***Important* REC-002-23 Driveshaft Separation Technical Instructions**

Xos Safety Recall REC-002-23

Driveshaft Separation

Figure 1 - Painted Rotor (Incorrect)

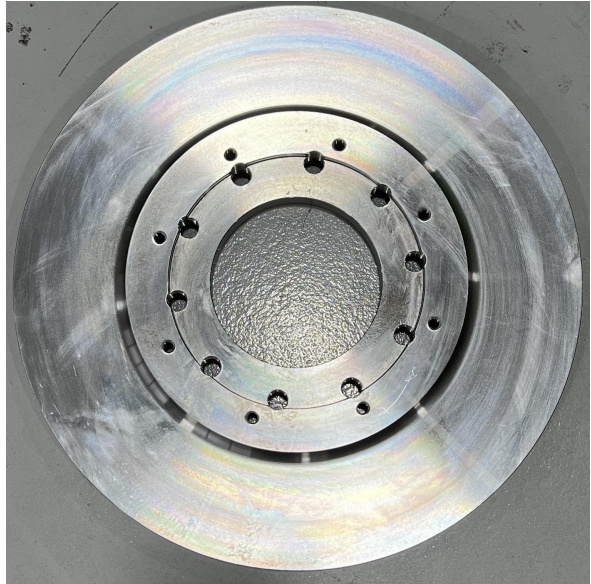
1. Visually inspect EPB Rotor.
2. Confirm all surfaces of the rotor to be completely unpainted.
 - a. If the surface is unpainted, the rotor will be reused after cleaning and tapping.
 - b. If the surface is painted, the rotor must be discarded and replaced with an unpainted one (**RM01-MB-M0044**).
